Addendum 1
File # 17-0466
Project: DECC Pipe Repair (DUL-DIST-17-01)

This addendum serves to notify all bidders of the following changes to the solicitation documents:

Figure 2- HW alignment facing North

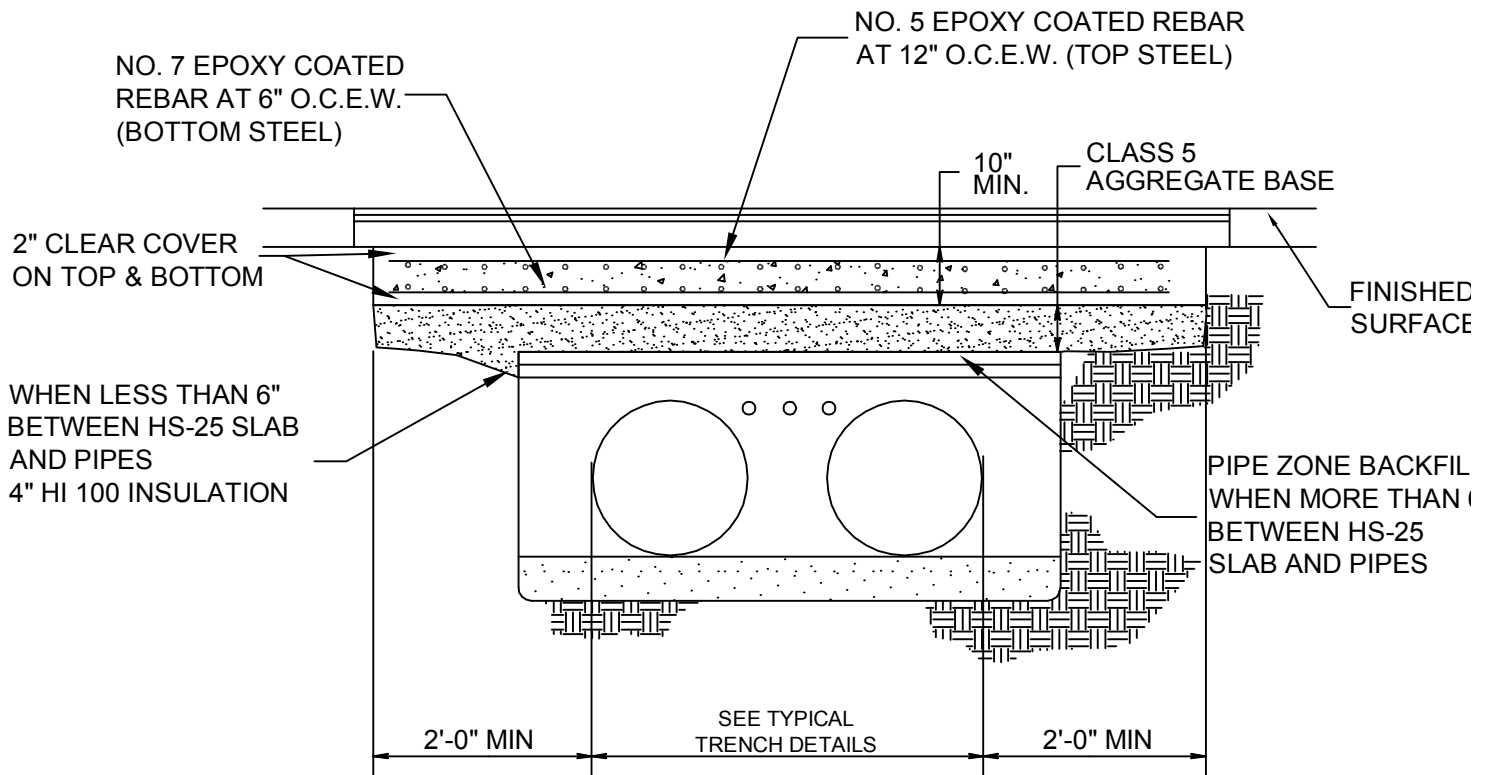
1. The weight of the 12" diameter pipe is 1,568 lbs and the pipe comes in 40-foot sticks.
2. Per attached pictures Figure 1, the rock retaining wall needs to be salvaged and reinstalled upon completion of the project.
3. Per the attached pictures Figure 2, the bollards shown need to be salvaged and reinstalled. If one is damaged during construction, the contractor is responsible for replacement.
4. Per the attached picture Figure 2, restoration of existing sidewalk is required.
5. Attached detail HS-25 Slab for shallow pipe is provided. Detail depicts how concrete slab at station 3+25 needs to be reinstalled. Slab will occur whenever cover over pipe is between 18" and 24".
6. The pre-bid meeting sign-in sheet is now posted on the City website.

Salvage and
reinstall Bollards

Restore sidewalk
to match original
